January 14, 2011

This letter, sent on behalf of the U.S. Army (Dr. David Goldblum), responds to concerns raised by the U.S. Nuclear Regulatory Commission (NRC) Technical Staff during the 21 and 25 January 2010 teleconferences regarding the site-specific partition coefficient (K_d) study. The teleconferences included members of NRC Technical Staff and staff from Science Applications International Corporation (SAIC), the Army's contractor. Specifically, NRC raised the following concerns:

Figure 1. Total Alkalinity Results versus Time for Rainwater Representativeness Testing Excluding Results for JP-KAC-013/SAIC01 at 48 Hours

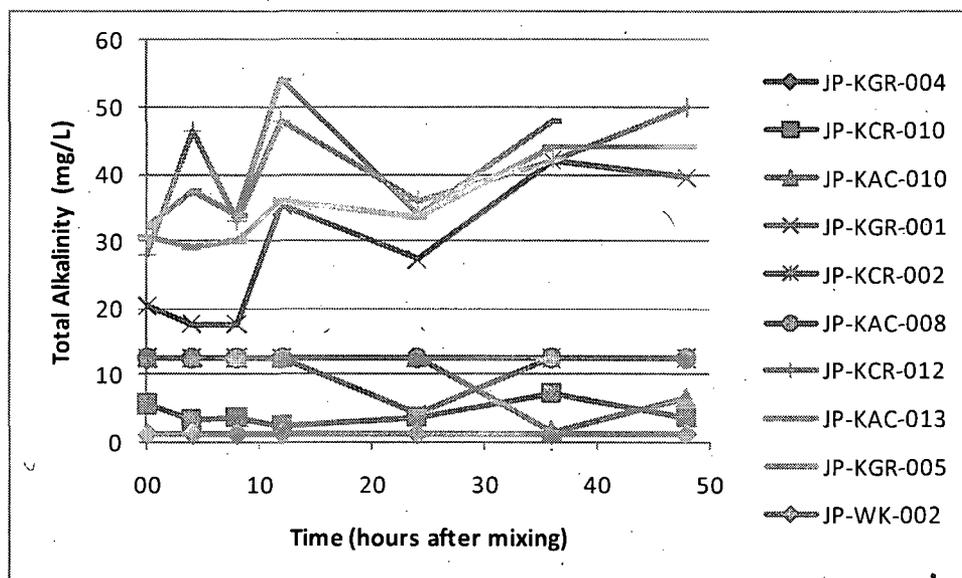
- Representativeness of rainwater to be used in the K_d study for subsurface soil samples (below 1 or 2 feet) as differences are expected in pH and alkalinity levels in rainwater at or near ground surface versus rainwater that has mixed with subsurface minerals with depth over time;
- Potential degradation that could have occurred since the time when the first 24 soil samples for the K_d study were collected in October 2008 with potential variation occurring in pH, organic carbon, or total organic carbon; and
- Potential losses of uranium adhering to filter container walls during the K_d study

NRC was concerned about the representativeness of rainwater to be used in the site-specific R_d study for subsurface soil samples. In particular, NRC was concerned about the differences between pH and alkalinity levels in rainwater at or near ground surface versus rainwater that had mixed with subsurface minerals with depth over time. These concerns are founded in the importance of pH on the migration of uranium through soil and water. However, it should be noted that NRC was not concerned with the use of rainwater as the leachant for the R_d study for surface and near surface soil samples because the majority of penetrators primarily reside and residual soil contamination remains at ground surface.

The average alkalinity across all testing times for the remaining four samples includes 55.6 mg/kg (JP-KAC-013/SAIC01), 40.5 mg/kg (JP-KCR-012 /SAIC01), 28.5 mg/kg (JP-KGR-001/SAIC03) and 35.3 mg/kg (JP-KGR-005/SAIC01). The average alkalinity level for JP-KAC-013/SAIC01 appears to be skewed by the final measurement taken at 48 hours (150 mg/kg). Eliminating the elevated 48-hour test result, the average alkalinity across all testing times in JP-KAC-013/SAIC01 falls to 39.9 mg/kg. The alkalinity test results plotted against time, while excluding the elevated 48-hour result for JP-KAC-013/SAIC01, are shown in Figure 1. In the four samples where alkalinity was measured above the reporting limit, the sample results fluctuate along a steadily increasing trend. While it does not appear that the alkalinity levels peaked within the 48-hour testing window, it should be noted that the laboratory R_d tests will last up to 45 days, which far exceeds the 14-day period recommended in the ASTM method. For each soil sample, the laboratory will prepare soil/water mixtures to enable sampling of each mixture for uranium analysis of the supernatant at predetermined time intervals (i.e., 3, 7, 10, 14, 21, 28, 35 and 45 days). The 45-day test period is believed to be sufficient to allow steady-state concentrations in the supernatant to be observed with the achievement of steady state anticipated about mid-way through the test period based on previous batch testing studies conducted by TestAmerica.

The alkalinities measured during the rainwater representativeness testing fall within the range of measurements observed during the site characterization in surface water and groundwater samples as shown in Table 3. The average alkalinity levels measured in samples collected during the site characterization were 104.8 mg/L in surface water, 341.5 mg/L in overburden groundwater samples, 297.1 mg/L in shallow bedrock samples and 330.5 mg/L in deep bedrock samples. If the increasing trends shown in Figure 2 are sustained, the alkalinity levels should intersect with average alkalinity levels measured in samples collected during the site characterization (approximately 300 mg/L) in 12 to 29 days (based on linear regression modeling). Therefore, the 45-day test period should be sufficient to reach steady-state conditions in the R_d study.
